City Council Meeting: June 14, 2011

Agenda Item: 8-B

Subject: Amendment to the Civic Center Specific Plan (11GPA-001) in regard to the Main Street Traffic Circle and Early Childhood Center (ECEC), and authorization of fee transfers related to the RAND Development Agreement

ADDENDUM TO THE CIVIC CENTER SPECIFIC PLAN EIR

Proposed Revised CCSP Illustrative Plan

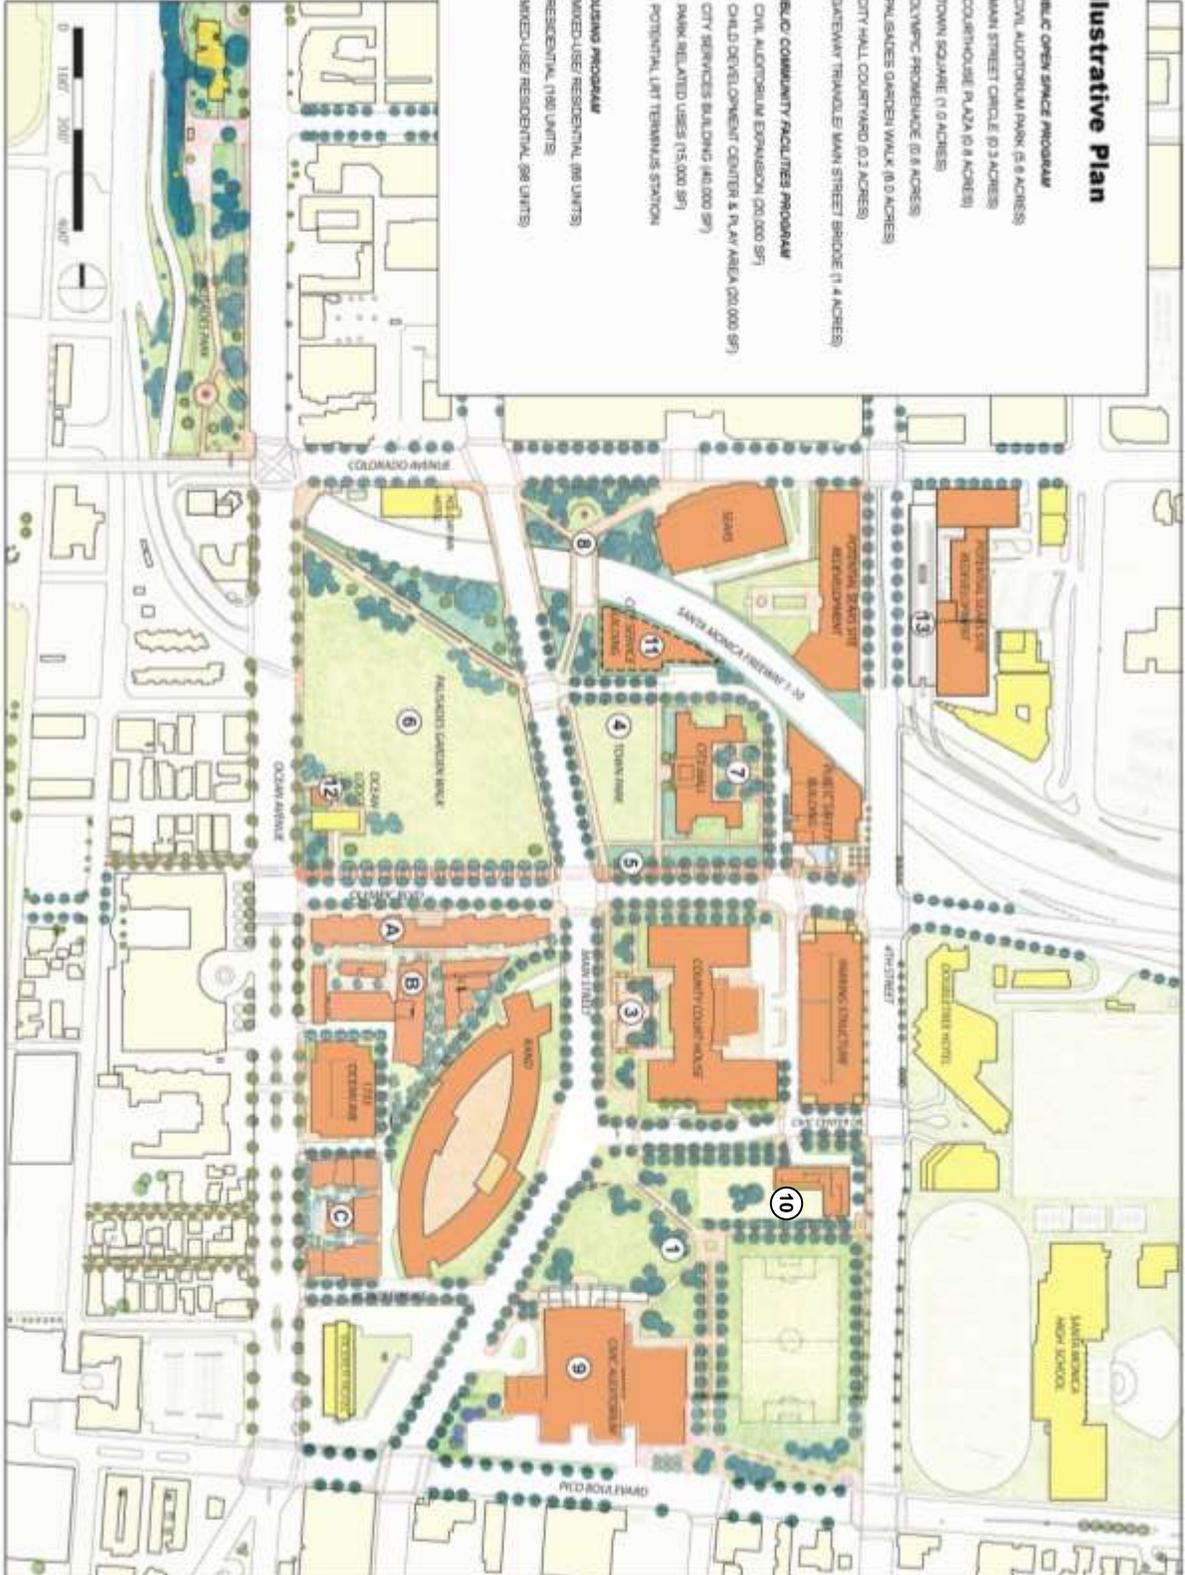
Please see Attachment C detailing the change (including the removal of the Main Street Circle) to the previous layout of the Civic Center Specific Plan area.

There will also be modifications to the graphics on pages: 6, 10, 12, 15, 20, 32, 34, 37, 39, 47, 50 and 52 to depict the new planned Main Street alignment without the Main Street Circle.

RAND Fee Transfers Exhibit

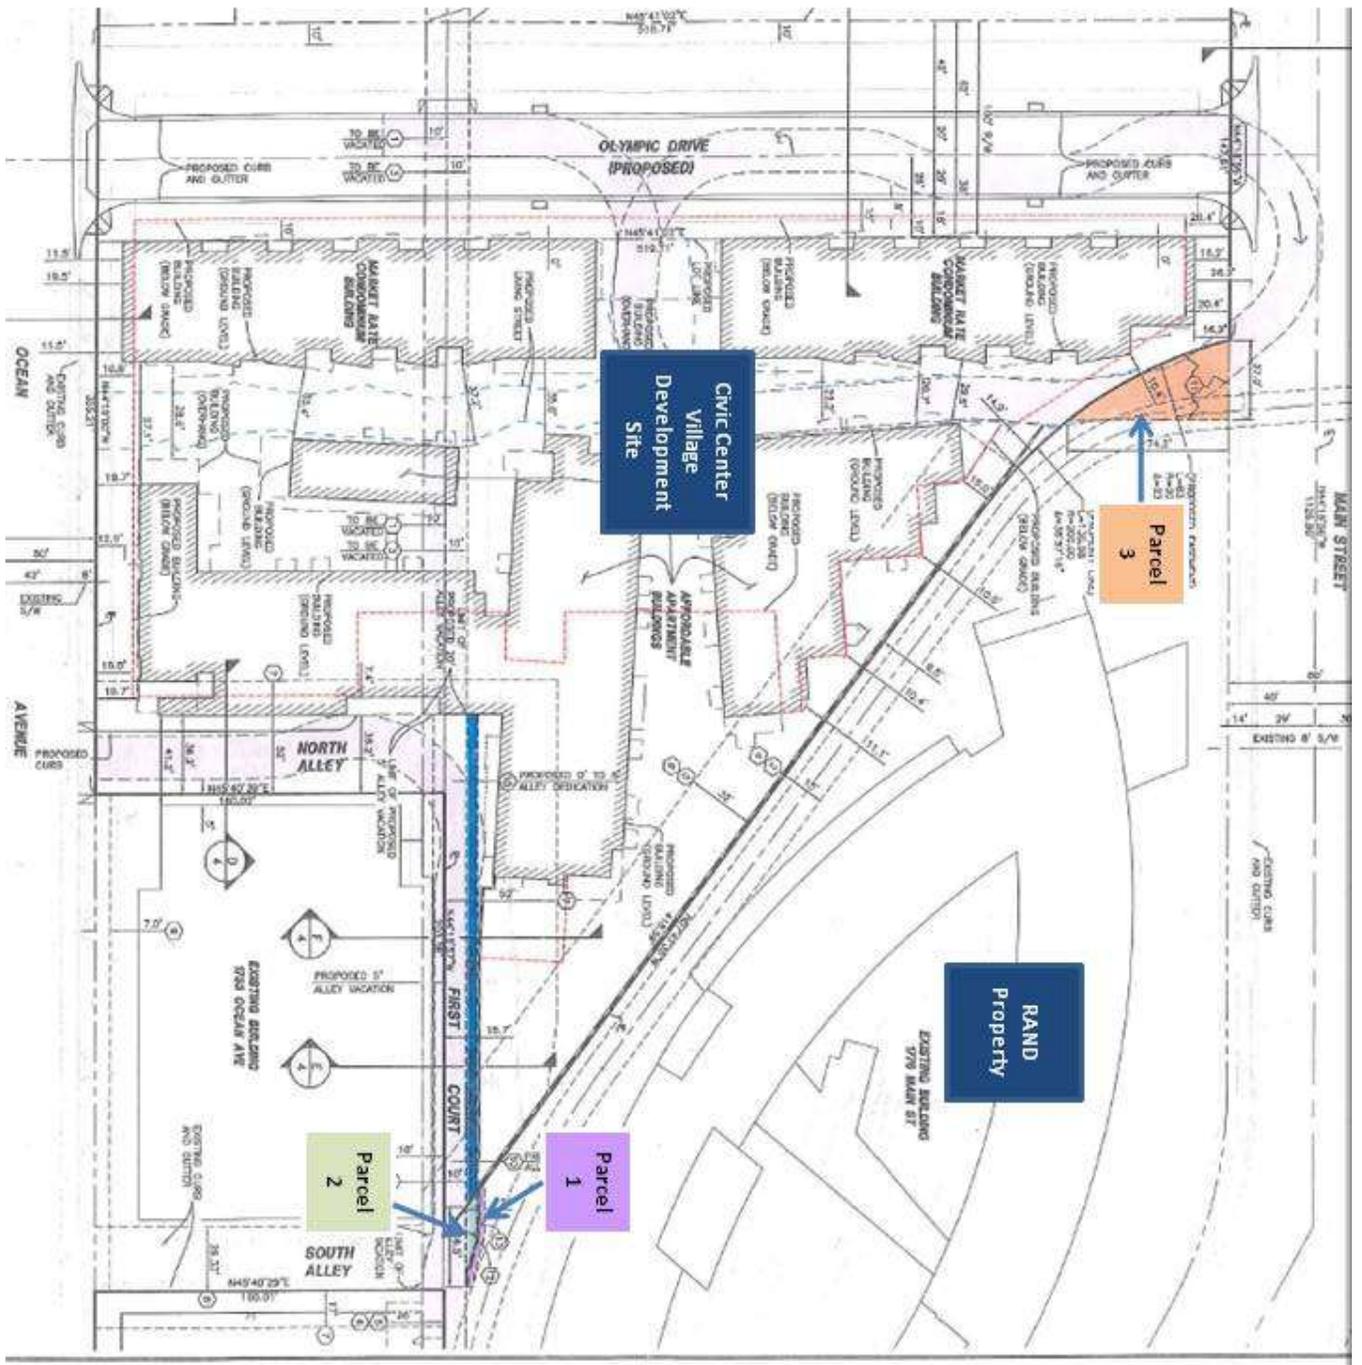
parcels are depicted in the attached Exhibit D titled “RAND Fee Transfers” and needed for the following Village elements:

- Parcel 1: Needed for the construction of a retaining wall for safe ingress and egress to the Village’s proposed subterranean parking garage accessible via First Court. This parcel is located on the north side of First Court on the RAND property adjacent to the Village site, totaling 141 square feet.

- Parcel 2: Needed for reconfiguration of First Court alley to provide for safe ingress and egress to the Village’s proposed subterranean parking garage accessible via First Court. This parcel is located on the RAND property abutting the north side of First Court adjacent to the Village site, totaling 135 square feet.

- Parcel 3: Needed for emergency vehicle and public access from Main Street to the Village site and the “Living Street” pedestrian walk. The Living Street design, which includes a central plaza with a strong connection to Olympic Drive and Palisades Garden Walk and a pedestrian-only walk street through the site from Main Street to Ocean Avenue, integrates the public and private areas with pedestrian access and landscaping to provide a wide range of interactive opportunities on the site. This parcel is located on the south side of Main Street along the northwest corner of the RAND property abutting the Village site, totaling 1,614 square feet.
